EMERGENCY AIRWORTHINESS DIRECTIVE

Number: G-2021-0014R1-E

Hot Air Balloons – Fuel – Cylinder Quick Shut-off Valve Mounting Flange – Inspection / Replacement

Figure 1: *CB437 Flanged Adaptors for Quick Shut-Off (QSO) valves*

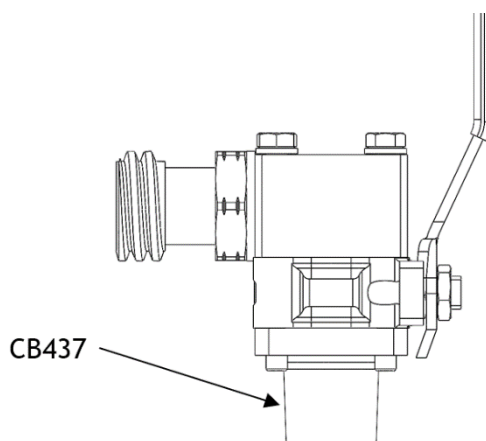
Certain Cameron Hot Air Balloon fuel cylinders are supplied with liquid offtakes that consist of a quarter turn ball valve mounted on a flanged adaptor (P/N CB437, see figure 1). Two recent batches of these adaptors have been manufactured with non-conforming (undersize) threads.

In certain cases, when the minimum sized adaptors are combined with cylinder bosses at maximum tolerance dimension and assembled to fuel cylinders, the thread can impinge ("bottom out") on the cylinder boss. Although the required tightening torque value can be achieved at installation, the torque required to unscrew the flange could be below the minimum value. In extreme cases the adaptor may be unscrewed by hand.

4. From the 04 October 2021 (the effective date of AD G -2021-0010-E), do not install an affected part on any cylinder.
5. Within 4 months after 04 October 2021 (the effective date of AD G-2021-0010-E), modify each cylinder by replacing the P/N CB437 issue F QSO flanged Adaptor, with a P/N CB437 issue H (or later issue) QSO flanged adaptor in accordance with the instructions of the SB, or by replacing the QSO valve assembly with a handwheel valve part No CB0824-0001 (this part has a Rego-type hose connection).
